SUBJECT: ISSUANCE OF AMENDMENT NO. 212 TO FACILITY OPERATING LICENSE NO. DPR-62 REGARDING THE FUEL CYCLE 12 RELOAD - BRUNSWICK STEAM ELECTRIC PLANT, UNIT 2 (BSEP 95-0299) (TAC NO. M93258)

AMENDMENT NO. 212 TO FACILITY OPERATING LICENSE NO. DPR-62 - BRUNSWICK, UNIT 2

Amendment No. 212
License No. DPR-62

SAFETY EVALUATION BY THE OFFICE OF NUCLEAR REACTOR REGULATION

SODIUM PENTABORATE SOLUTION VOLUME CONCENTRATION REQUIREMENTS
FIGURE 3.1.5-1

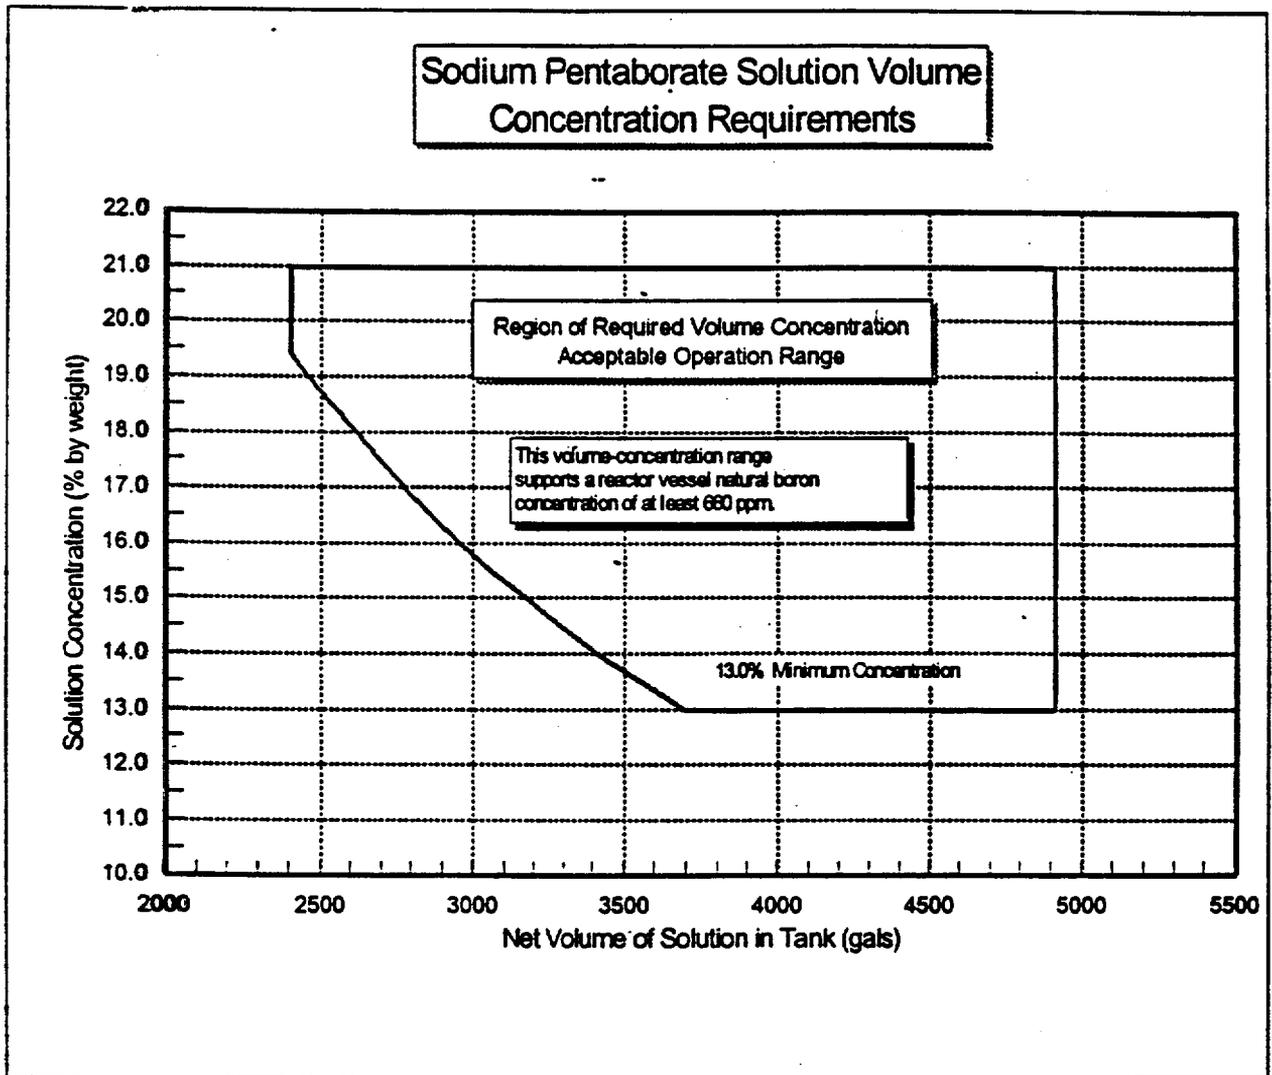
(3) Figure 3.1.5-1

A portion of the standby liquid control system (SLCS) sodium pentaborate volume-concentration range shown in TS Figure 3.1.5-1 (applicable to the lower range of tank volume) is being revised to increase the required concentration of sodium pentaborate solution to account for the additional shutdown reactivity needed based on the planned use of GE13 fuel assemblies as reload for the Unit 2 Cycle 12 reactor core. For the currently approved fuel types, a minimum shutdown margin of 2.6%ΔK is required in the SLCS analysis; and for the GE13 fuel type, GE methodology requires a shutdown margin of 3.6%ΔK. GE calculations show that an in-vessel concentration of 660 ppm boron results in an estimated SLCS shutdown margin of 4.1%ΔK, which exceeds the minimum required shutdown margin of 3.6%ΔK, based on the current minimum SLCS tank concentration of 13% by weight. The proposed increase in the required concentration of sodium pentaborate solution to raise in-vessel concentration from 600 ppm to 660 ppm is acceptable for this plant-specific application, since the proposed concentration results in a higher shutdown margin than the required minimum of 3.6%ΔK. In addition, GE has committed during a January 4, 1996, conference call to submit its methodology for generic review in response to the staff's question on the documentation of the previous methodology used in support of this application.

The NRC staff has concluded that the changes to the TS regarding the use of GE13 fuel and the revised MCPR safety limit are acceptable for the BSEP Unit 2 reload application since the changes are based upon methodology and acceptance criteria previously approved by the NRC staff. In addition, previous industry experience has shown that the GE methodology that was used in establishing the revised shutdown margin requirement is conservative. Since GE has calculated that the proposed increase in the required concentration of sodium pentaborate solution results in a higher shutdown margin than the required minimum, the proposed concentration change is acceptable.
